October 03, 2024

**RE: 808 Montoya St. NW**  
**Grading and Drainage Plan**  
**Engineer's Stamp Date: 09/26/2024**  
**Hydrology File: H12D030**

ENGINEER'S SEAL	LOT 7 LANDS OF FEDELINA RODARTE 808 Montoya St NW	DRAWN BY DEM
		DATE 9-25-24
9/26/24	GRADING AND DRAINAGE PLAN	808 Montoya St NW.DWG
DAVID SOULE P.E. #14522	 <i>Rio Grande Engineering</i> PO BOX 83624 ALBUQUERQUE, NM 87199 (505) 321-9099	SHEET # C1
		JOB #  _____

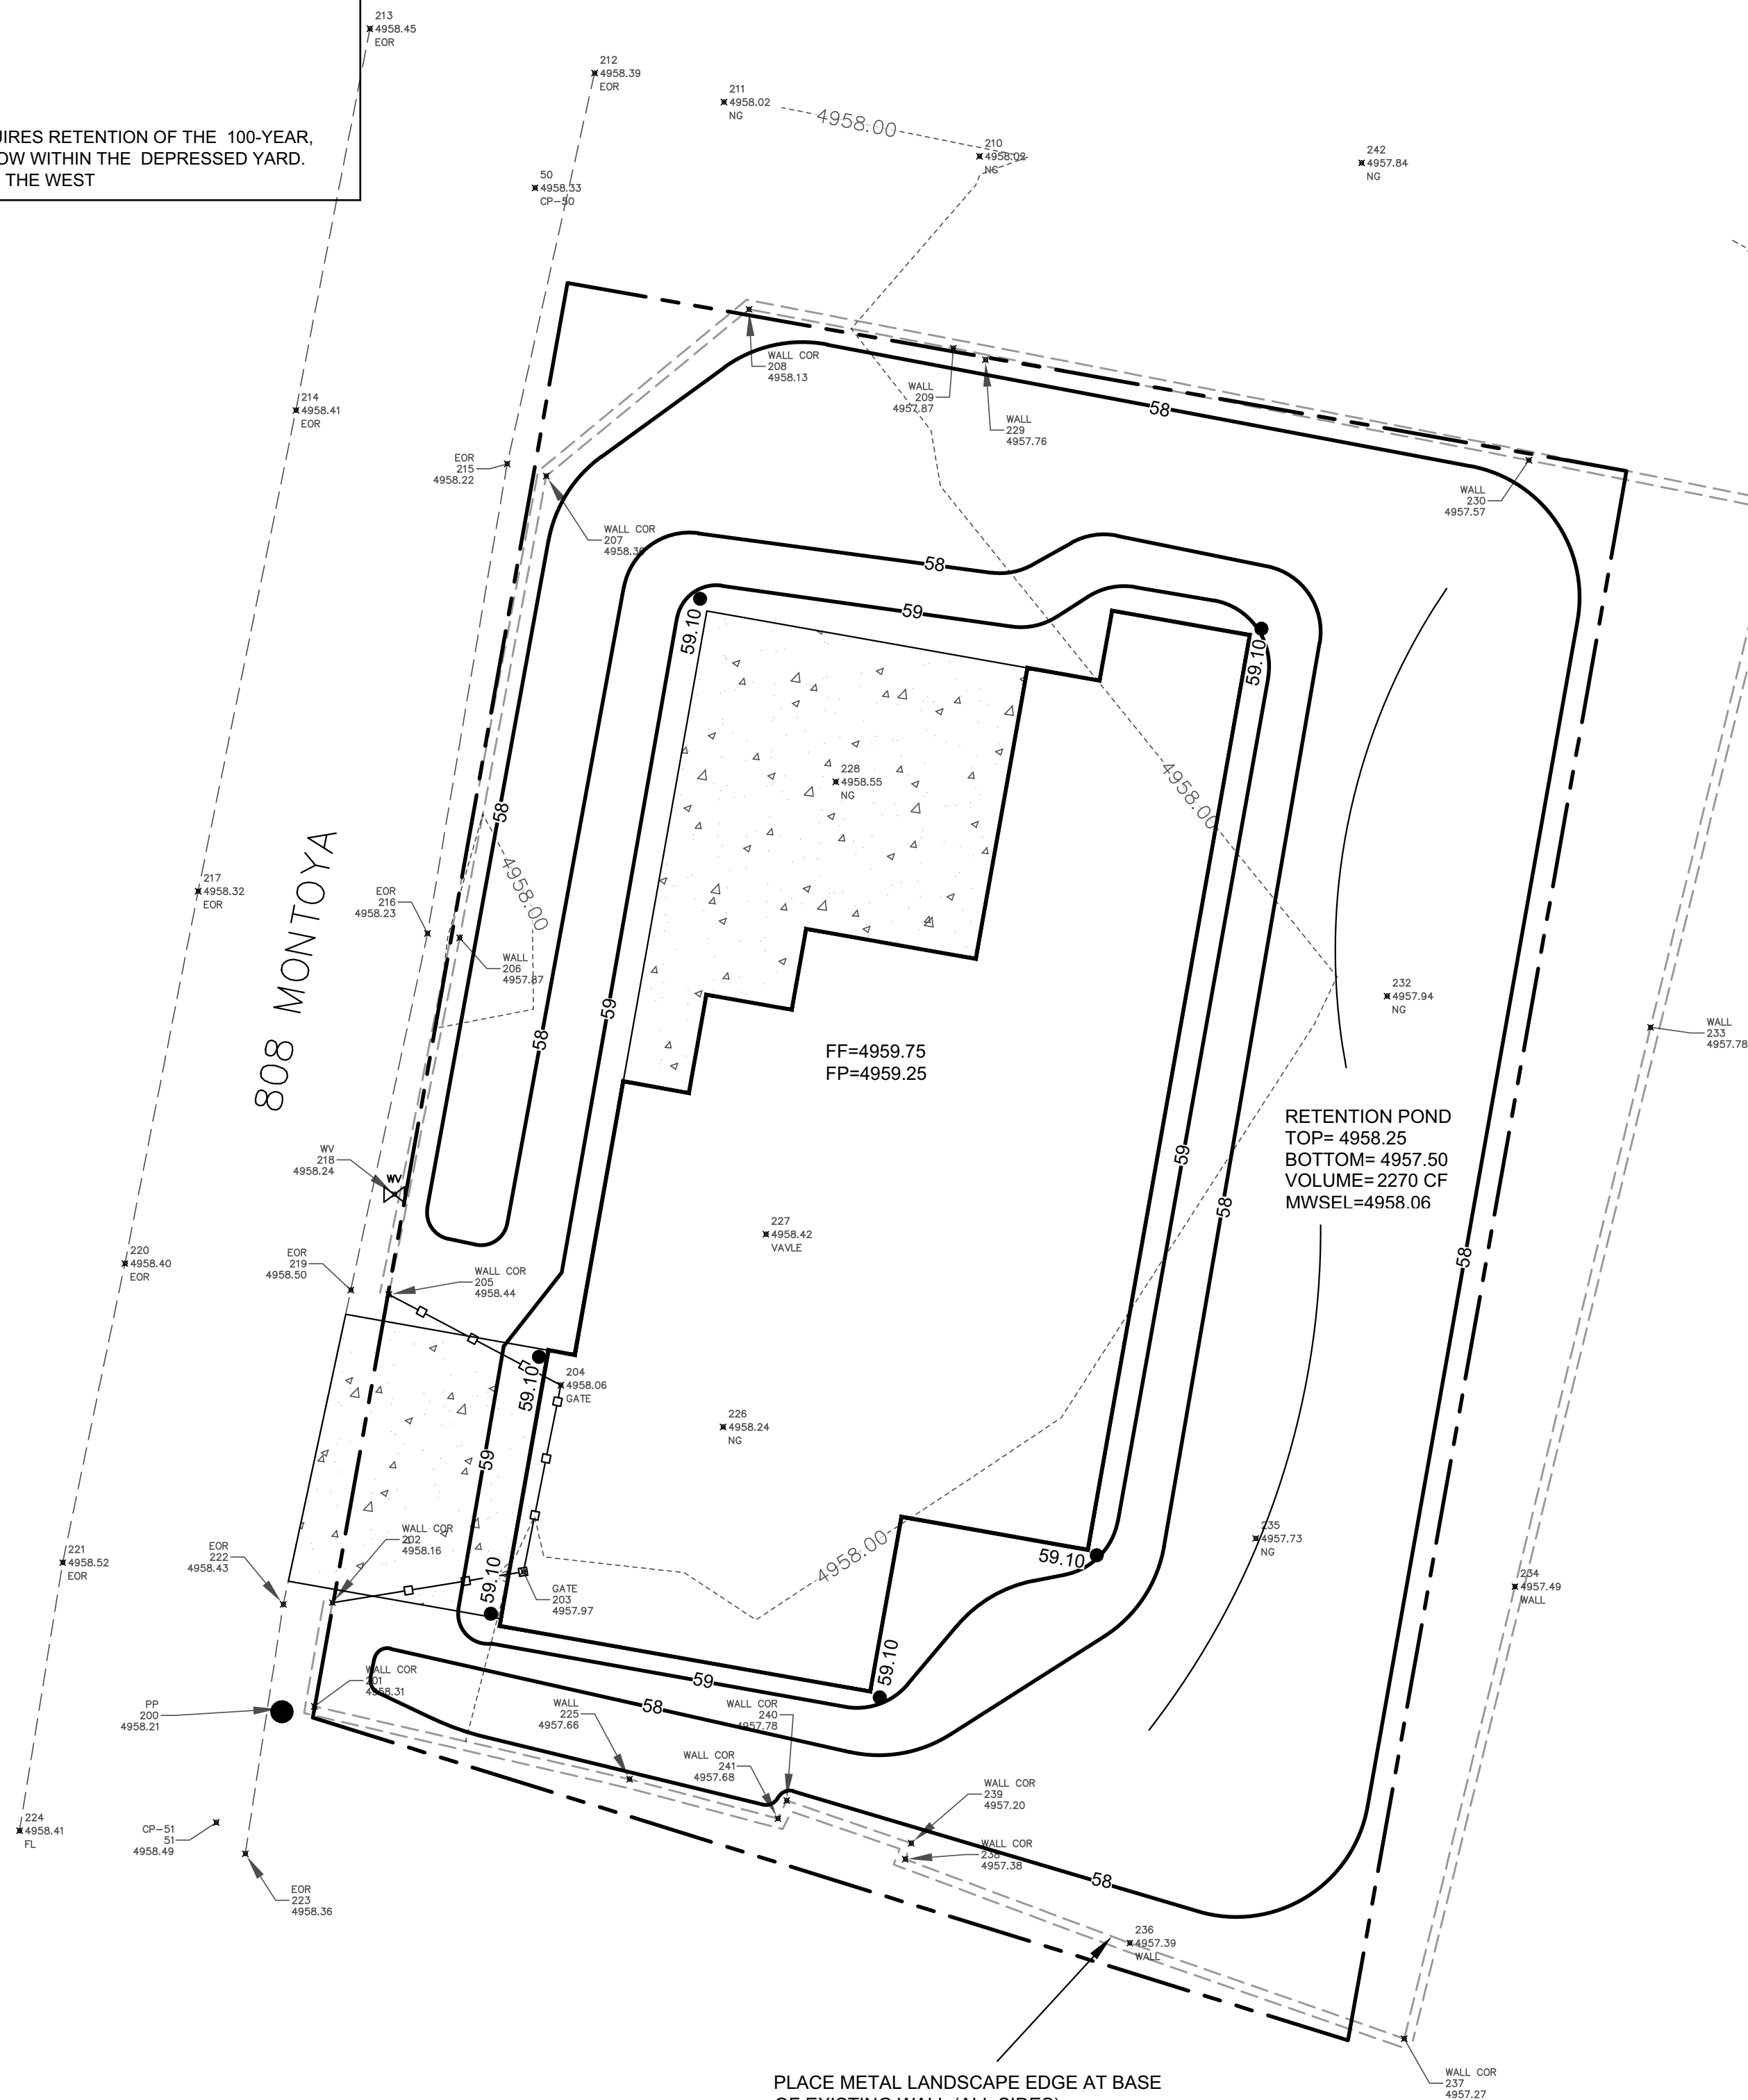
Based upon the information provided in your submittal received 09/27/2024, the Grading & Drainage Plan is approved for Building Permit and Grading Permit. Please attach a copy of this approved plan in the construction sets for Building Permit processing along with a copy of this letter.

1. Engineer's Certification, per the DPM Part 6-14 (F): *Engineer's Certification Checklist For Non-Subdivision* is required.
